Calculation Title: Appendix E – PMP Development Version Log	Calculation No.: CDQ0000002016000041	Rev. No.: 001	Sheet: E1
--	---	------------------	--------------

Calculation Title: Appendix K – Review Board Letter	Calculation No.: CDQ0000002016000041	Rev. No.: 001	Sheet: K1
--	---	------------------	--------------

(Figure 30, Local Storm PMP, page 73) The Local Storm PMP values need to be revised in the southwestern area of the Appalachian Mountains where there is a significant discontinuity in the spatial distribution of 6-hour Local Storm PMP values. This discrepancy is due to the discontinuity in the precipitation-frequency relationships in the two versions of NOAA 14. The discontinuity of spatially mapped values are not meteorologically plausible and the discontinuity significantly detracts from the credibility of the proposed values in the southwestern area of the Appalachian Mountains. The analysis in this area must be reviewed and adjustments made to produce a coherent spatial distribution for Local Storm PMP.

Figure 3. Regional groupings for daily data used to prepare NOAA Atlas 14 Volume 2

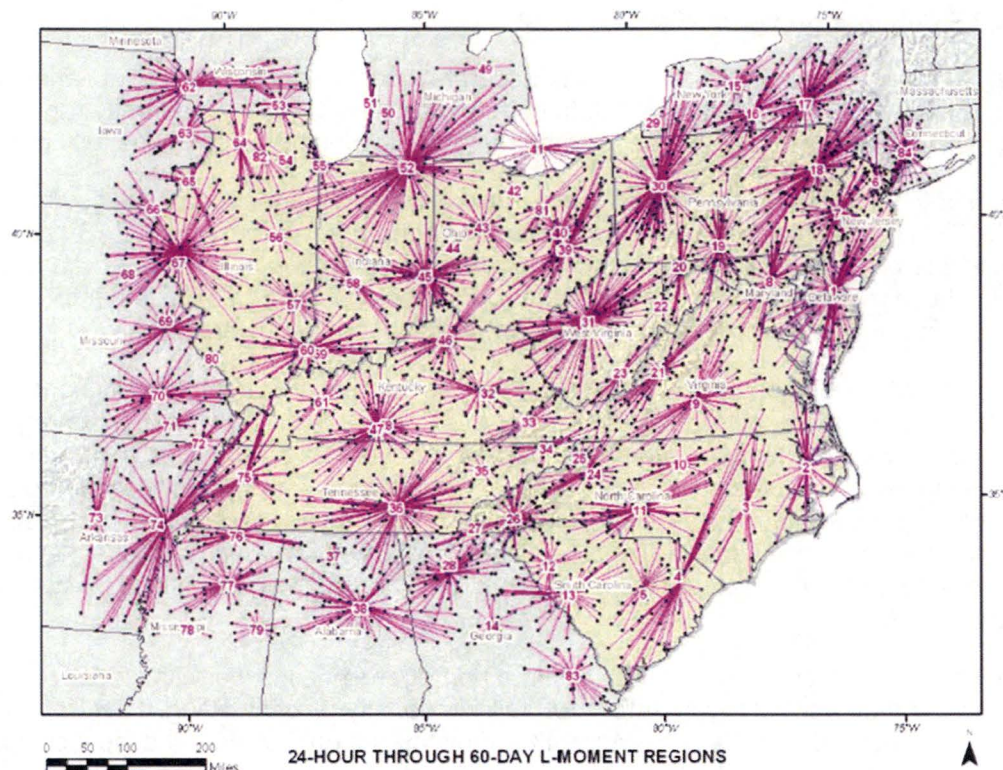
However, during the development of the PF data, Atlas 14 identified homogeneity zones (i.e., regional groups) for data pooling. Based on Section 4.2.2 of Atlas 14, Volume 2, the regional application of L-moments derives *“the shape parameters from all stations in a homogeneous region rather than from each station individually.”* From Section 4.4 of Atlas 14, Volume 2: *“effort was made during the subdivision process to mitigate discrepancies that could be caused by (1) sampling error due to small sample sizes, or (2) regionalization that does not reflect a local situation.”* Figure 3 shows the 24-h through 60-day regional groupings identified in Atlas 14, Volume 2.

Generally speaking, all precipitation data within a homogeneity zone were first locally normalized, and then pooled together for probabilistic density function fitting. Therefore, it is important to understand that the NWS Atlas 14 values do not only capture the local precipitation features. It is jointly influenced by the local mean (of annual maximum series at each gauge), regional probability density distribution, and final interpolation by PRISM.

Figure 13. Local Storm, SPAS 1209 (Wooster, OH) rainfall mass curve (left) and dew point analysis (right)

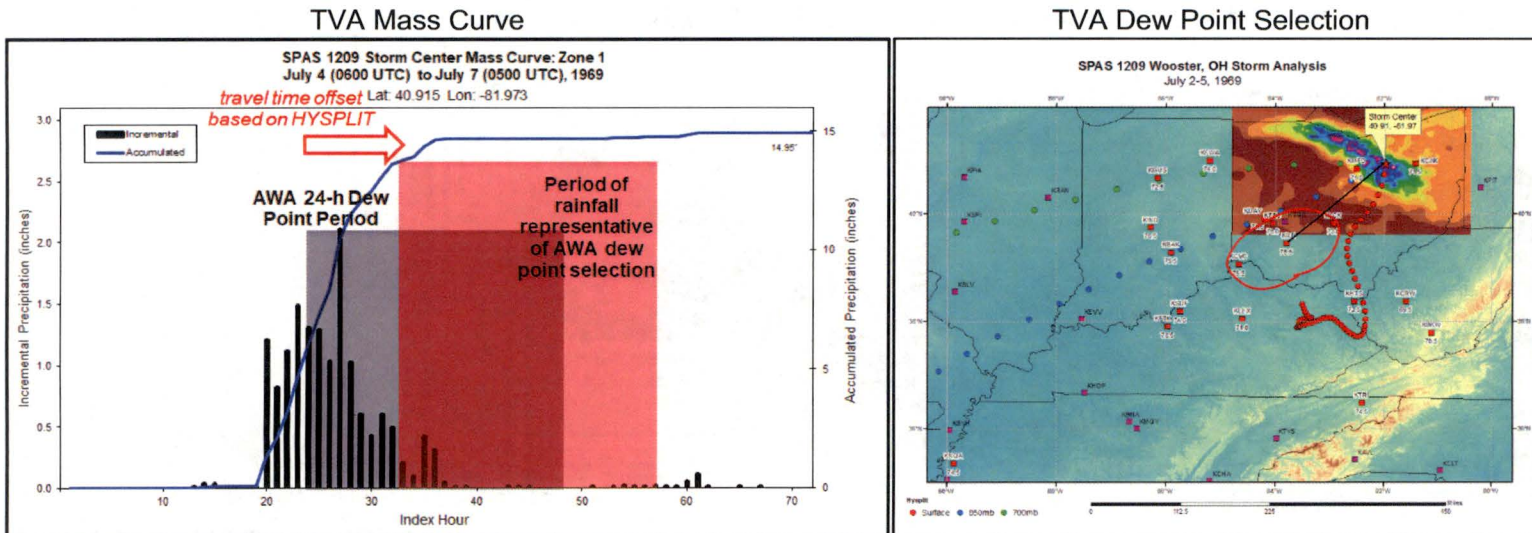
3. Tropical Storm, SPAS 1276 (Wellsville, NY) – see Figure 9
 - a. The licensee's dew point temperature observations correspond to a period when the most intense rainfall occurred. The representative dew point location is approximately 385 miles SSW of the storm center location.

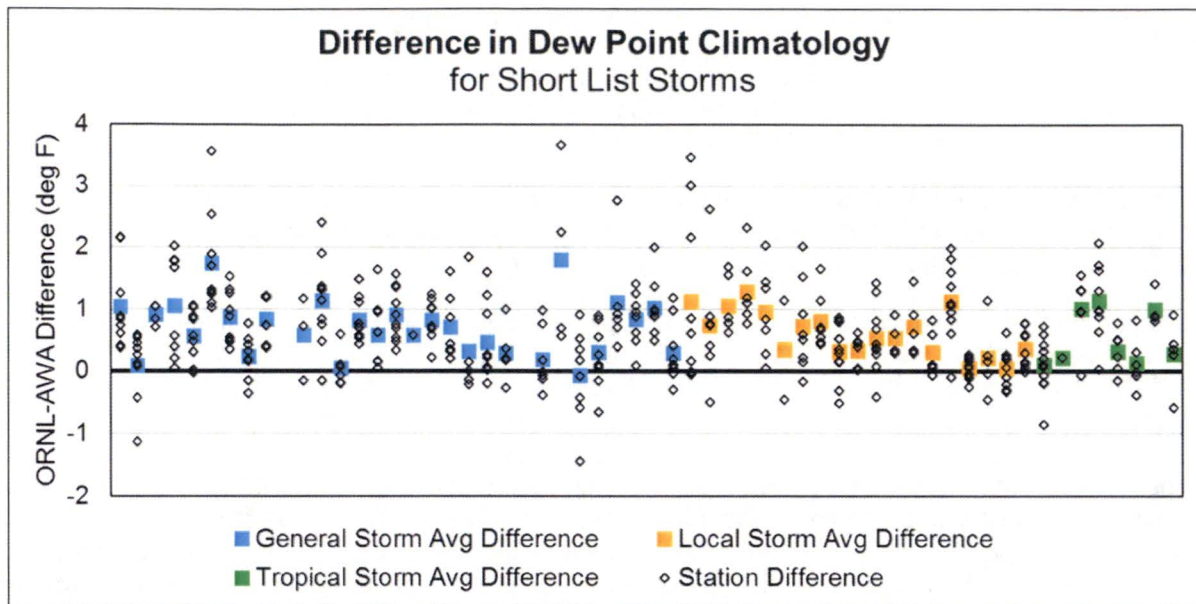
Figure 15 shows the difference in the NRC and TVA dew point climatology values for each comparable station for all short list storms. The stations selected represent the stations which would have most influenced the dew point climatology at the transpositioned moisture source location and for which climatology values were available from both the TVA and NRC data sets. Positive values indicate that NRC's evaluation resulted in higher dew point climatology values than TVA, while negative values indicate that NRC's evaluation resulted in lower dew point climatology values than TVA. On average, the difference for General, Local, and Tropical storms is +0.69 F, +0.61 F, and +0.52 F, respectively, with an overall average station difference of +0.65 F. Individual station differences range from -1.44 F to +3.67 F.

TVA Figure 2. Smethport, PA and Simpson, KY adjusted rainfall plotted on the world record depth-duration curve

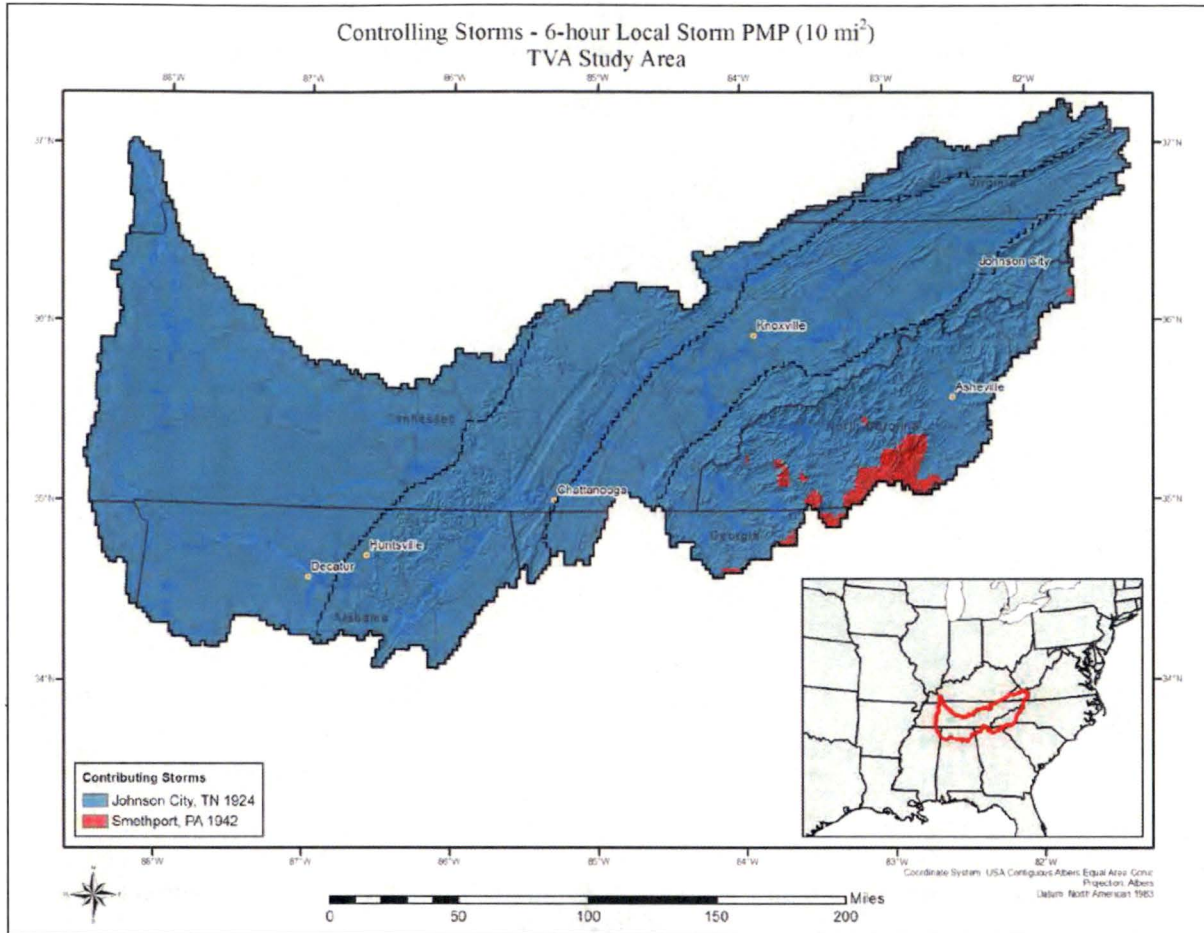
Although it is possible that the Smethport, PA storm is not transpositionable to any part of the TVA basin, no conclusive data existed to eliminate the storm. However, several data adjustments suggested this possibility. This included anomalously high OTF values and high MTF values. In these types of situations where there is no clear argument for inclusion or exclusion, the TVA choice is made to include the storm. In doing so, adjustment factors and fit with other adjusted storms must be considered, similar to the discussions in HMR 51 Section 3.2.2 and Section 3.2.4. Use of the storm and the storm adjustment values as calculated, resulted in unreasonably high rainfall depths when transposing the storm from north central Pennsylvania to the TVA basin. An MTF value greater than 1.00 results from the fact that the target grid locations in the TVA basin are closer to the moisture source region than the area associated with the storm center in north central Pennsylvania. More significantly, much of the target region has greater precipitation frequency depths due to more frequent extreme rainfalls and enhanced orographic influence. This results in calculated total adjustment factors at the target grid locations that are greatly inflated where the OTF values can exceed 2.00.

However, after further review and discussion with the NRC staff in regard to this question, TVA has agreed to add further conservatism and revise the OTF determination methodology used in LIP calculations. This methodology change ensures the OTF used in transpositioning local storms to the SQN, BFN and WBN plant sites is not less than 1.0. Note, this change only affects the Simpson, KY storm because the Smethport, PA storm was not transpositioned to the plant sites. Updates to this data set will affect Sections 6.1.1.5 and 6.4.4 of Calculation No. CDQ0000002016000041 and will be submitted as Revision 1 to Topical Report TVA-NPG-AWA16 (TVA Calculation CDQ0000002016000041).

TVA Figure 14. 24-hour 100-year precipitation illustrating discontinuity between volumes for 35° N

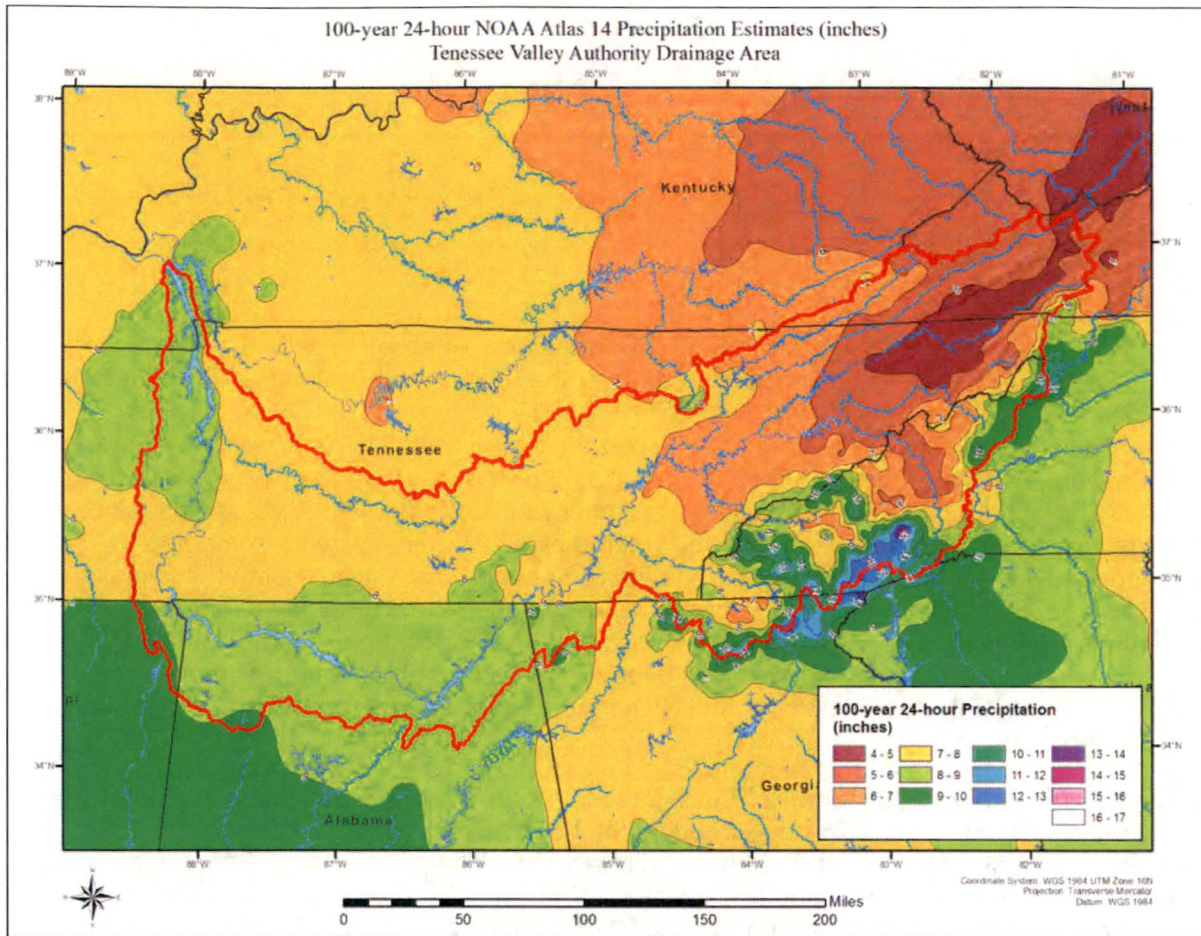
Request:

Local storm PMP utilizes the 6-hour Atlas 14 precipitation frequency grids for OTF calculations. At the 6-hour duration, the boundary issue exists along the 35° N state boundaries similarly to the 24-hour duration. Furthermore, there is also a significant discontinuity over the Tennessee/North Carolina/Central Georgia state border. The depth of rainfall over the Hiwassee River drainage basin south of 35°N (Atlas 14 Volume 9) is significantly less than north of 35°N (Volume 2), as shown in TVA Figure 15.

TVA Figure 16. Example of general storm PMP before constant OTF adjustment

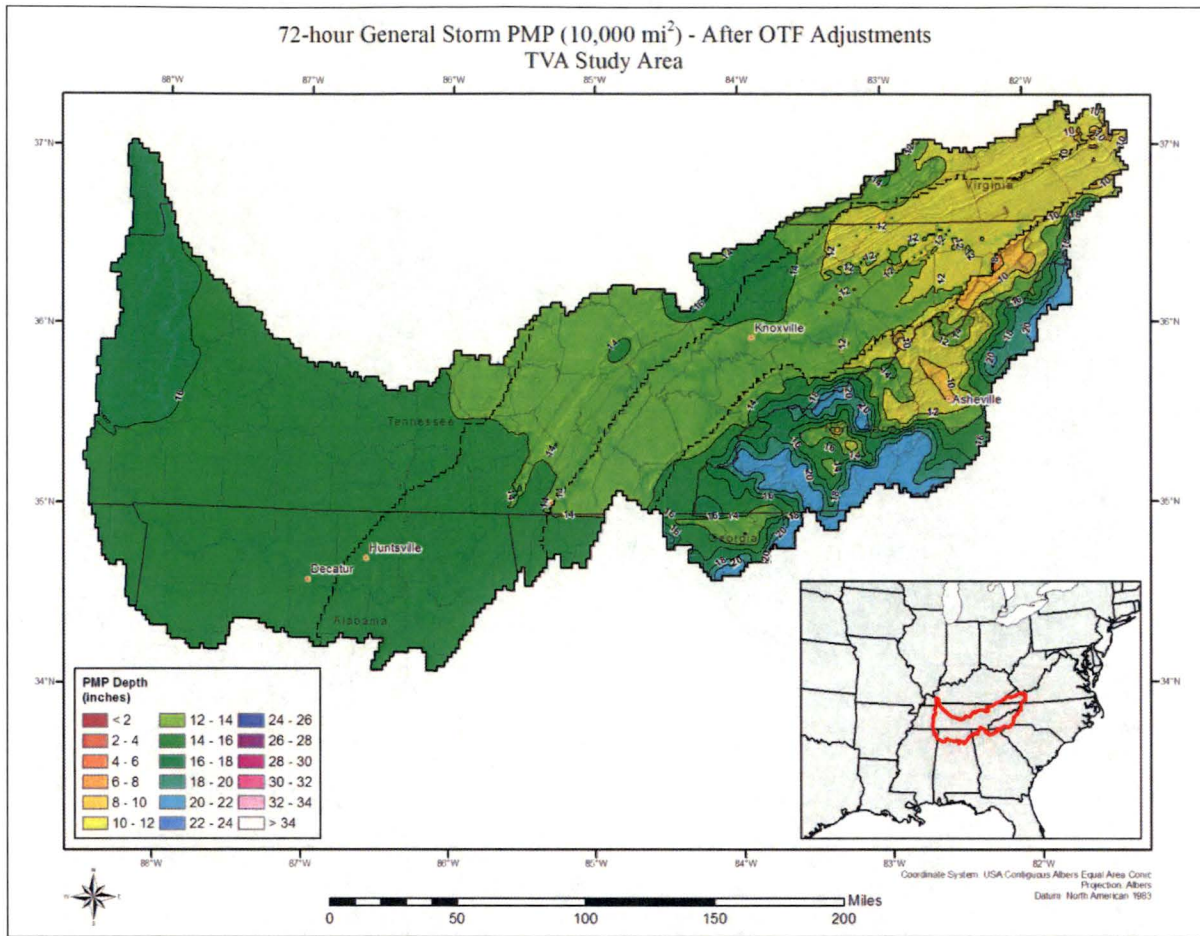
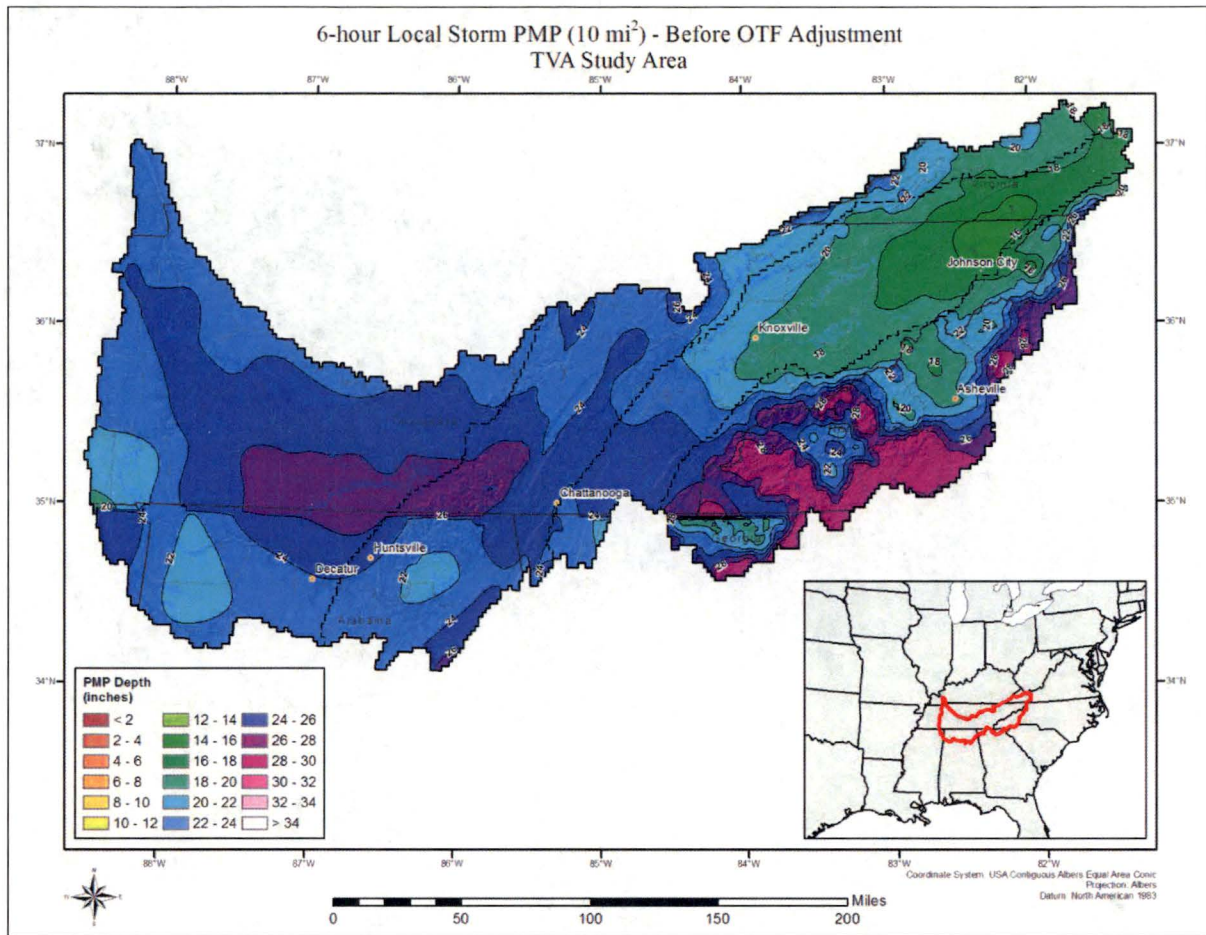
In addition, the area in red shown in NRC Figure 6 was reevaluated due to the significant disparity between the Atlas 14 volumes over the Hiwassee drainage area. The OTF for this area was recalculated in a similar way to the process described above for the western region of the project area where a representative location was chosen and each grid point within the area of interest (AOI) was assigned the OTF from the representative location. For this area, the absolute cell reference representative location was chosen as a point within the basin near the outlet of the basin at 35.15° N, -84.45° W. Due to the highly orographic nature of the AOI, a constant OTF reassignment alone is not sufficient; therefore an elevation adjustment factor was applied to the constant OTF to estimate the orographic effect over the AOI. The elevation adjustment factor was determined as the ratio of elevation at the target location to the elevation at the representative location, which is 1,624'. A sixth root is applied to sufficiently mute the ratio to be consistent with the surrounding OTF values outside the AOI.

An example map of general storm PMP before the constant OTF adjustments over the western portion of the project area is provided in TVA Figure 16. TVA Figure 17 shows the same PMP map after the general/tropical storm OTF adjustments are implemented.

TVA Figure 17. Example of general storm PMP after constant OTF adjustment

TVA Figure 30. TVA transposition map for the Larto Lake, LA September 2008 storm

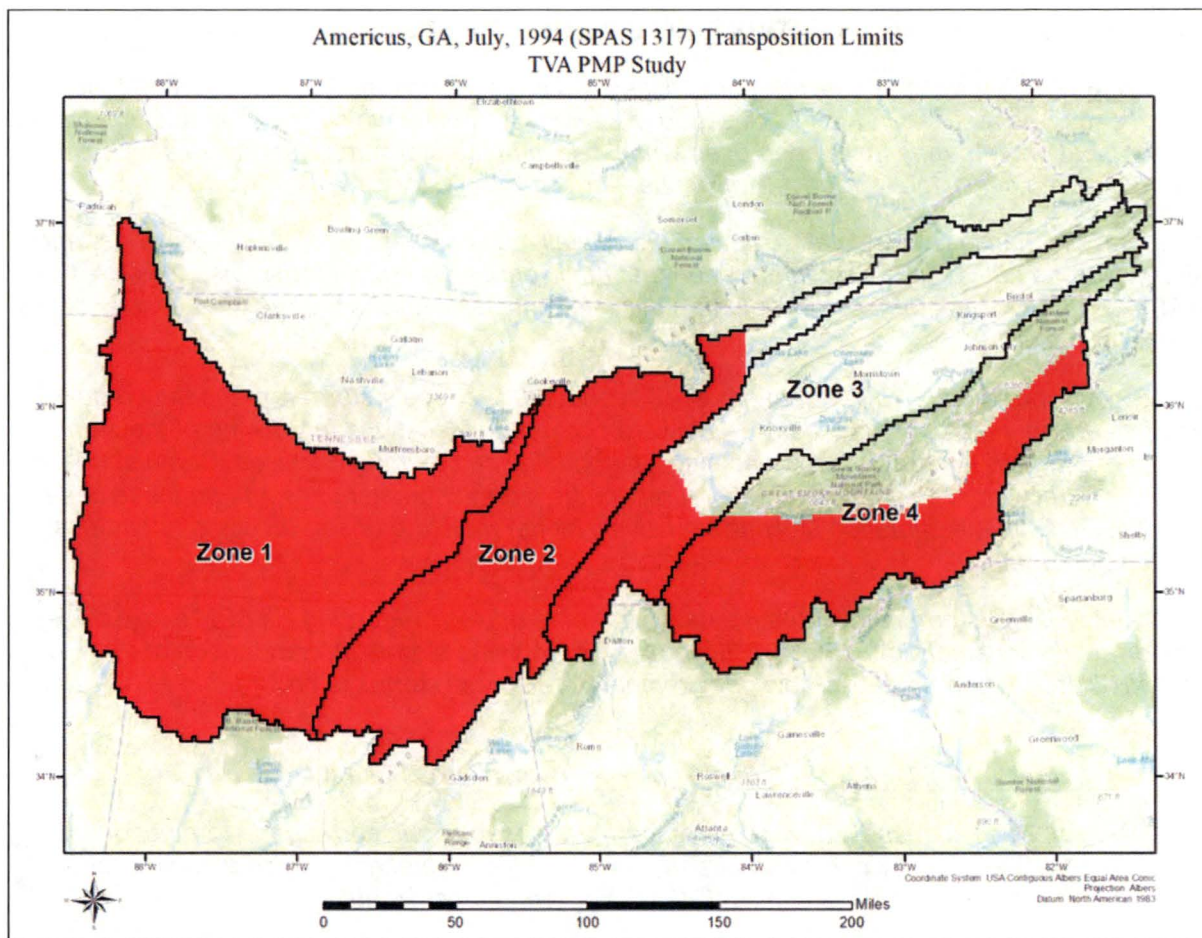
Each storm on the final storm short list was evaluated for explicit transposition limits. TVA transposition Zones (1-4) were used as initial reference for all storms. Further refinements between and within zones took place only as required based on unique individual storm characteristics and/or maintaining spatial continuity of adjustment factors and PMP depths.

TVA Figures 24-29 display the transposition limits applied to storms by the NWS, which occurred in similar regions as Larto Lake, LA and Americus, GA events. Each of these figures clearly demonstrates that the NWS did not consider storms in these regions transpositionable to the Tennessee Valley and specifically to the interior regions of the Tennessee River basin. In fact, the custom limits applied by TVA (TVA Figures 30 and 31) are significantly more conservative than the NWS transposition limits. TVA allowed these storms to affect the southern portions of the TVA region to ensure appropriate spatial continuity in PMP values between these regions and to account for the uncertainty of where the exact boundary would occur. However, the rainfall that occurred with the storms would not occur in the same meteorological and topographical setting existing over the interior TVA regions. Note, this does not mean that remnant tropical moisture doesn't produce rainfall in that region. Instead the magnitude of those rainfall events is significantly reduced because of the different interactions of topography and meteorology, thereby violating the definition of transpositionability. This requires that remnant tropical storms that occurred in similar meteorological and topographical settings be used in that region. This excludes the Larto Lake, LA and Americus, GA storms from consideration.
